## OFFICE OF ENVIRONMENTAL SUSTAINABILITY

### INSPECTOR'S REPORT ON AN APPLICATION FOR A CERTIFICATE OF AUTHORISATION FOR A CLOSED LANDFILL

<b>TO:</b>	Dr. Eimear Cotter, Director
<b>FROM:</b>	Ewa Babiarczyk, Inspector, Environmental Licensing Programme
<b>DATE:</b>	24 <sup>th</sup> January 2020
<b>RE:</b>	Application by <b>Cavan County Council</b> for a Certificate of Authorisation for a closed landfill at <b>Dunaree, Kingscourt, County Cavan</b> . Certificate of Authorisation Register Number <b>H0016-01</b> .

Figure 5: Gas monitoring locations

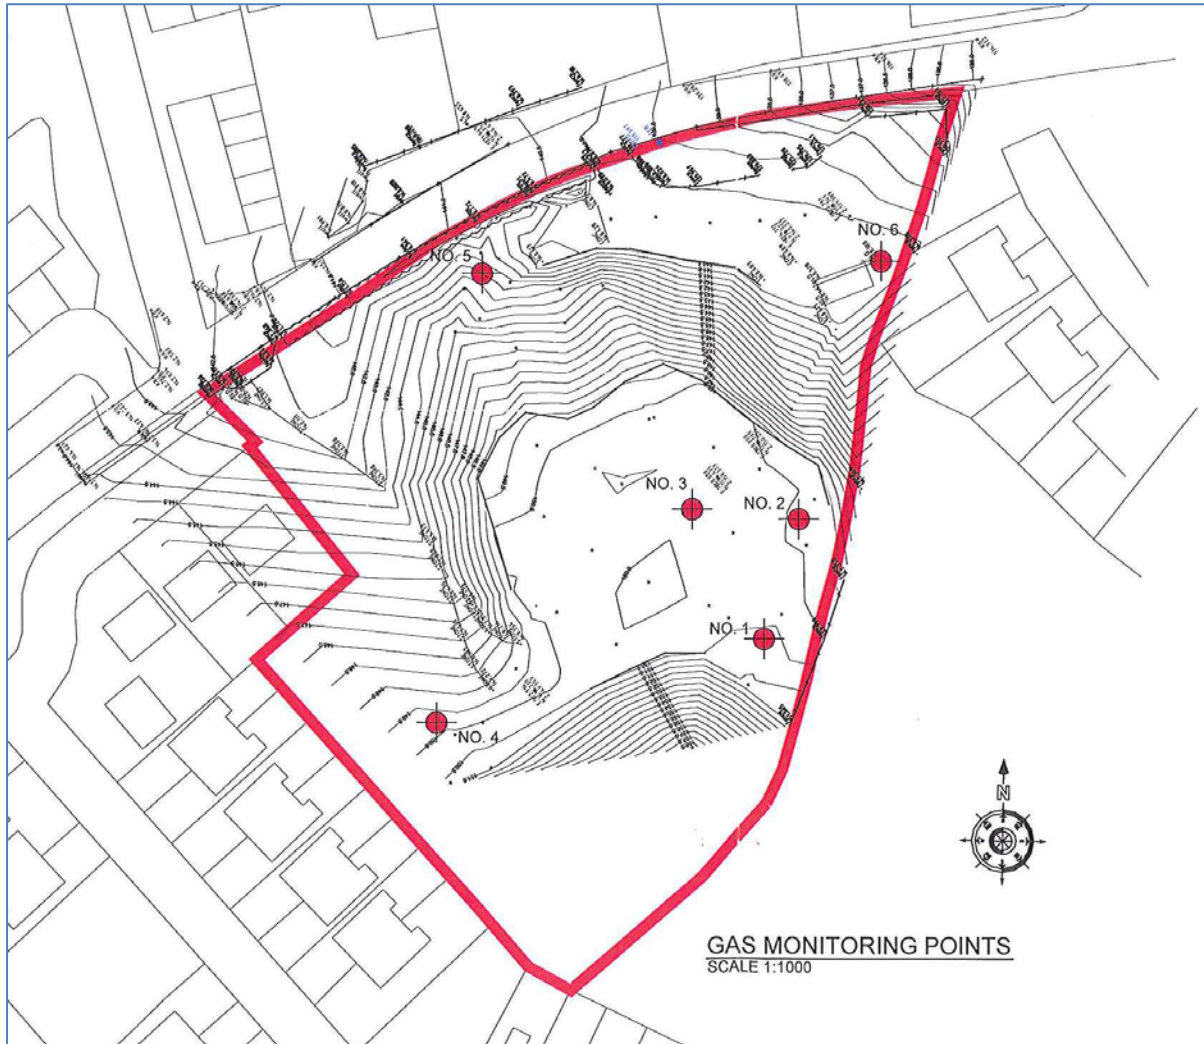
Landfill gas:	<p>There is a risk of landfill gas migration to nearby houses. The most likely pathway for the migration of the landfill gas is through the underlying bedrock and existing landfill cap.</p> <p>The most recent gas monitoring was carried out at six monitoring locations MW1 to MW6 (as shown in Figure 5) on 17<sup>th</sup> October 2019. The monitoring results show that Methane (CH<sub>4</sub>) concentrations varied from 1 to 1.1 % v/v at MW1, MW2, MW4 and MW6. Carbon dioxide (CO<sub>2</sub>) varied from 0.1 to 1.7 % v/v with 1.7 % v/v recorded at MW2 and 0.1 % v/v recorded at MW4, MW5 and MW6. The amount of gas generated at the closed landfill is insufficient for utilisation or flaring.</p> <p>The findings of the Tier 2 and Tier 3 Environmental Risk Assessment gas monitoring established that the majority of gas being generated at the former landfill is most likely escaping through the surface, due to the shallow depth of the landfill and the composition of the existing landfill cap. However, the findings further state, the lateral migration of landfill gas cannot be disregarded given the subsurface rock, fill material and as both Methane and Carbon Dioxide are heavier than air. Condition 3.1 requires a landfill cap, to include a 1mm thick low permeability geomembrane and a passive gas venting system. Additionally, Condition 3.8(c) requires monitoring to detect the presence and concentration of landfill gas on a quarterly basis.</p>

<ul style="list-style-type: none"> <li>• Stability of the side slopes;</li> <li>• Enhanced surface water drainage;</li> <li>• Reduction in the infiltration of rainwater;</li> <li>• General landscaping and scenic amenity.</li> </ul> <p><u>Landfill Gas Monitoring</u></p> <p>There are six gas monitoring wells currently installed at the site. As part of a continued programme of monitoring it is proposed to install three additional gas monitoring wells at the site. In combination with the existing six gas monitoring locations the new gas monitoring locations will be positioned on both sides of the passive gas venting system in order to show whether gas is breaching the gas venting barrier and to test the effectiveness (or otherwise) of the gas venting system.</p> <p>Having regard to the monitoring results submitted in support of the application for certificate of authorisation, the age of the closed landfill, the location of the nearest private well (within 800m of the site) and the fact that the nearby dwellings are serviced by Kingscourt Public Water Supply (PWS code: 0200PUB1015_1), the following remedial measures are considered appropriate and recommended in Condition 3.1:</p> <ul style="list-style-type: none"> <li>(a) install of a low permeability landfill cap, minimum 1m, with 1mm thick low permeability geomembrane having a hydraulic conductivity of less than or equal to <math>1 \times 10^{-9} \text{m/s}</math>;</li> <li>(b) install passive gas venting system. The gas vent pipes shall not be perforated above the ground level;</li> <li>(c) install additional gas monitoring wells as recommended in Tier 3 Assessment;</li> <li>(d) regrade the landform of the closed landfill; and</li> <li>(e) reseed grass within the site.</li> </ul> <p>Additionally, Condition 3.8(c) requires monitoring to detect the presence and concentration of landfill gas on a quarterly basis.</p> <p>The proposed remedial actions are intended to break the SPR linkages by preventing:</p> <ul style="list-style-type: none"> <li>• migration of leachate into the bedrock;</li> <li>• migration of landfill gas to off-site locations.</li> </ul> <p>The proposed capping will also prevent any waste materials from appearing on the surface of the landfill site.</p> <p>The recommended certificate of authorisation allows for the importation and use of soil and stone to complete the works.</p>

Figure 6(a): Conceptual site model for Kingscourt Landfill site – Cross section A-A

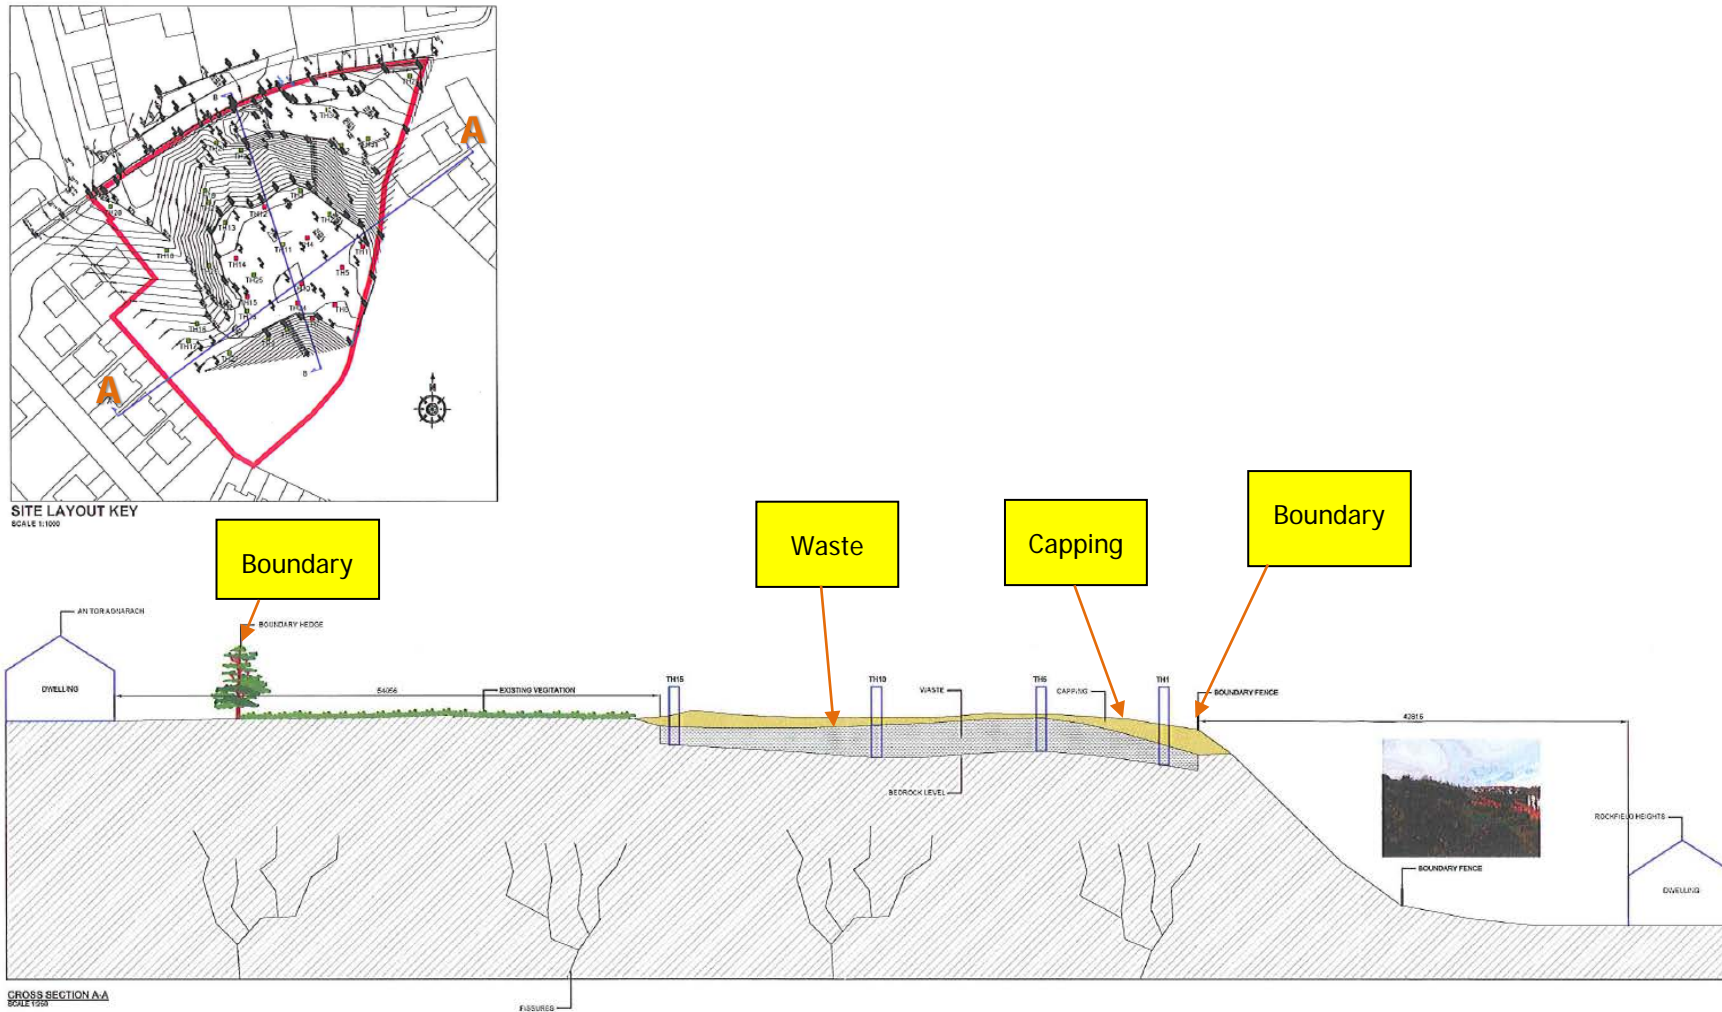
Conceptual site model:	<p>Trial hole investigations carried out as part of Tier 2 revealed that the extent of the deposited waste was significantly smaller than it had been initially thought after Tier 1 Risk Assessment. This resulted in the change of a number of SPR linkages and the reduction of overall risk rating of the site from High Risk (class A) down to Moderate Risk (class B).</p> <p>The conceptual site model is shown in Figures 6(a) and Figure 6(b).</p>
